ELECTRICS T.I. BULLETIN INDEX

Number	EL004
(JCB Gen 085; C65/N. Am.)	
Issue	1
Date	Sep. 1998

SUBJECT: Replacement Transmission Solenoids

Number	EL005
Issue	1
Date	Nov. 1998

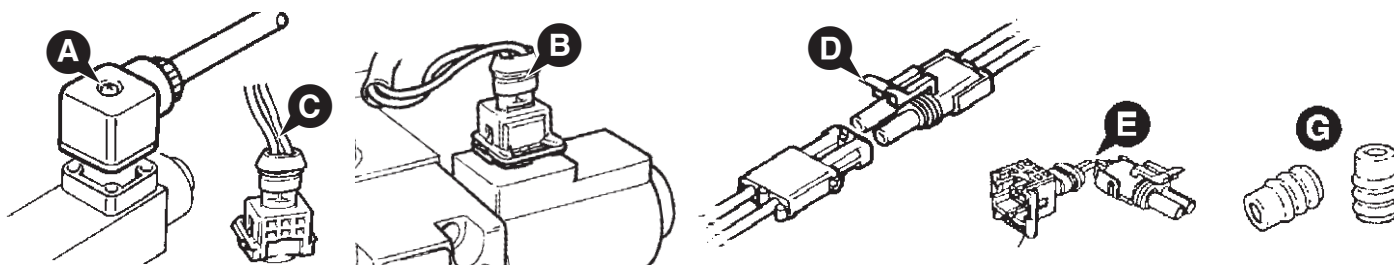
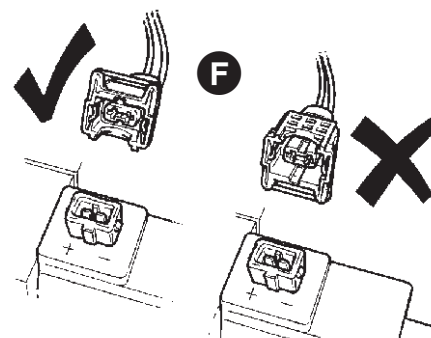
Replacement transmission solenoids with connectors type **A** have been superseded to the current connector type **B**. To change this type of connector the machine harness will have to be modified by splicing on a new connector **C**. Refer to JCB T.I. 2/174 (C45 N. Am.) March 1997 and JCB General Bulletin 020 (C30 N. Am.) Feb. 93.

Solenoids with connectors type **D** have also been superseded to the current type connector type **B**. To enable this type of connector to be used, link harness **E** is available for service use.

IMPORTANT NOTE: All later solenoids have diodes built into the coils. The diodes will be damaged if the coil is connected with reverse polarity causing the coil to fail and the fuse to blow.

Identify the positive wire on the machine, note the solenoid coil is marked positive and negative, connect the wires into the new connector the correct way round as shown at **F**.

Ensure the wire seals **G** are fitted to the plug to prevent water ingress.

Item	Part Number	Description
C	993/69600	Connector
E	718/44900	Link Harness

SUBJECT: Introduction of Hobbs Gear Lever with Dedicated Neutral Line Page 1 of 2

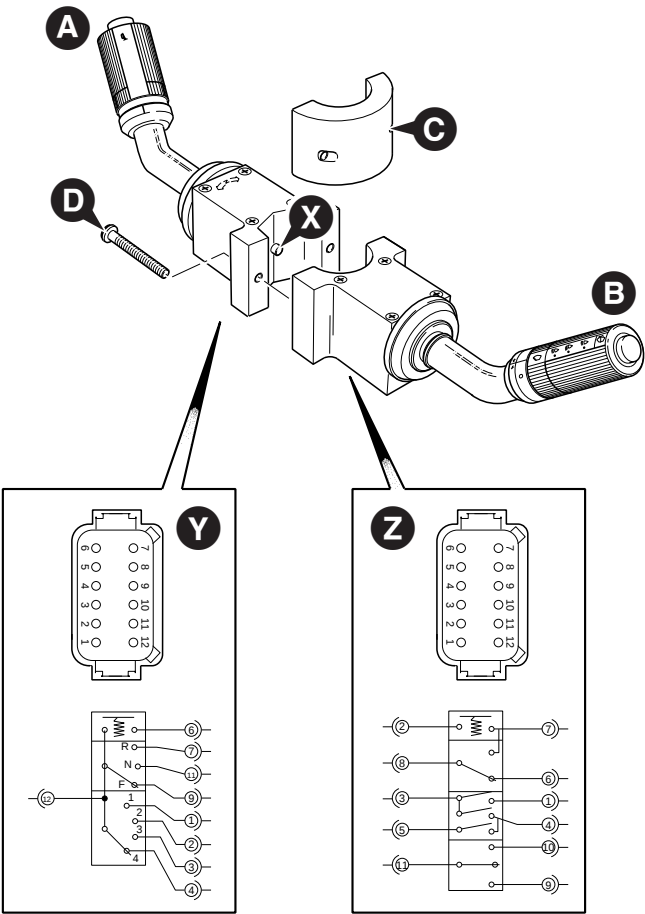
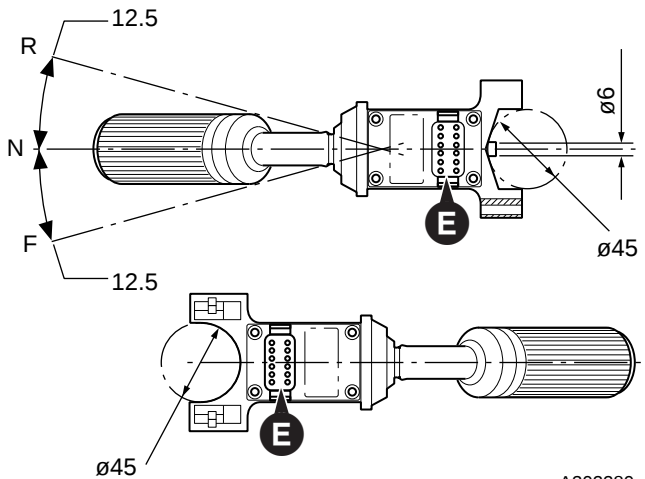
A new Powershift forward, reverse and speed change lever, ITL part number 475/51090, was introduced from July 1998 in order to simplify OEM wiring.

The new lever has a different 12 pin Deutsch wiring connection and provides a dedicated neutral circuit feed.

In order to fit the new lever in place of the old lever the machine wiring must be modified by adding an additional explicit neutral feed to the transmission ECU and changing the harness plug.

The illustrations show both a gear switch **A** and a multi-function switch **B**. Item **A** incorporates a locating pin **X** which engages with a drilled hole in the column to ensure correct location and prevents rotation of the switch mounting. The two switches are clamped onto the shaft using two screws **D**. If item **B** is not required, mounting clamp **C** should be used instead.

Note: An explicit neutral line is incorporated to simplify the neutral start circuit (i.e. no additional relays are required to decode neutral).

Connectors **E** must be protected by a suitable cover against damage and high pressure washes.

SUBJECT: Hobbs Wiper/Turn Signal Column Switch

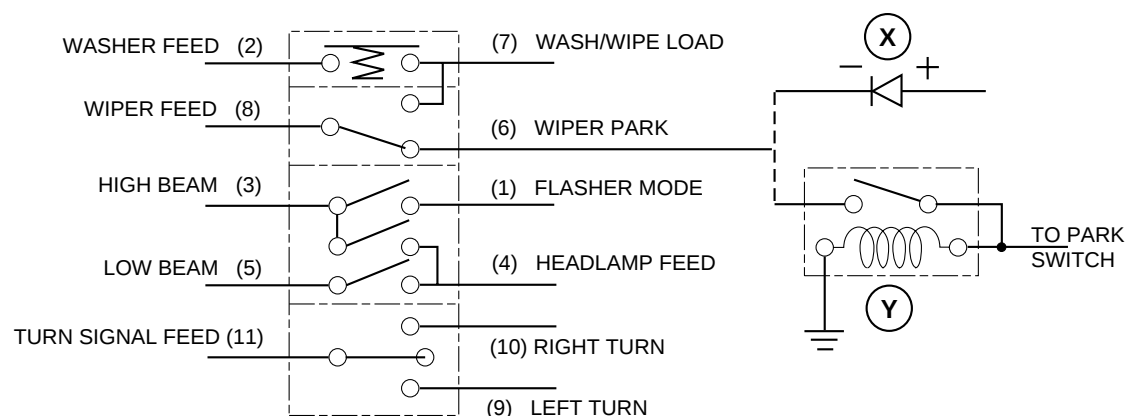
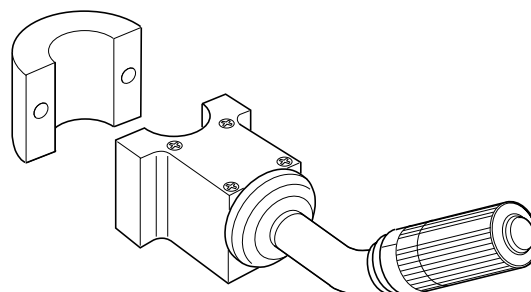
Investigation into reports of the wiper fuse failing when the wiper control is operated slowly has identified that when the wiper park circuit is grounded to earth and not relay controlled as shown on the illustration at **Y**, to prevent a short circuit in the lever, a diode should be installed into the wiper circuit at **X**. This is common electrical practice and is not a 'defect' in the lever.

Install a diode (capable of 5A minimum or suitably rated for the wiper motor amperage) as shown at **X** or use a relay as shown at **Y** to switch the wiper to park. The location of the diode is at the OEM's discretion.

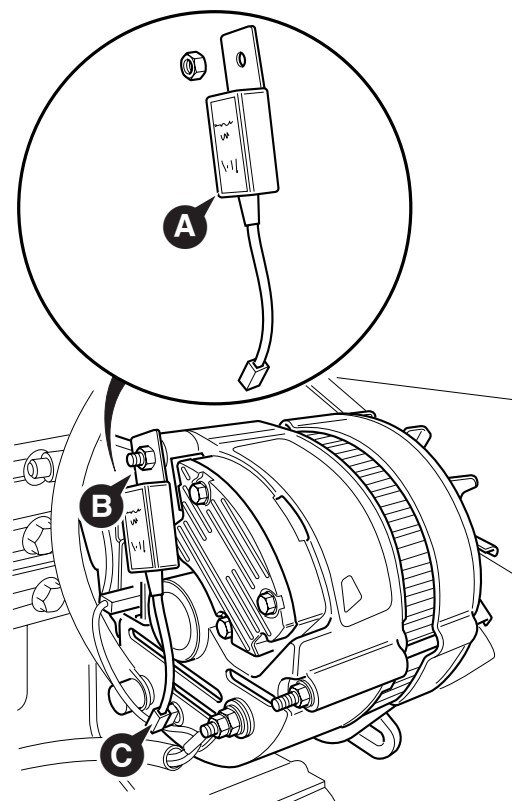
- 1 Park the machine on firm level ground, engage the parking brake and set the transmission to neutral. Lower the loader arms to the ground. Switch OFF the engine and remove the starter key.
- 2 Disconnect the battery.
- 3 Fit suppressor **A** onto bolt **B** and connect to terminal **C**.
- 4 Reconnect the battery, start the engine and check for correct operation.

Item	Description	Part No.	Qty
A	Suppressor	714/10801	1
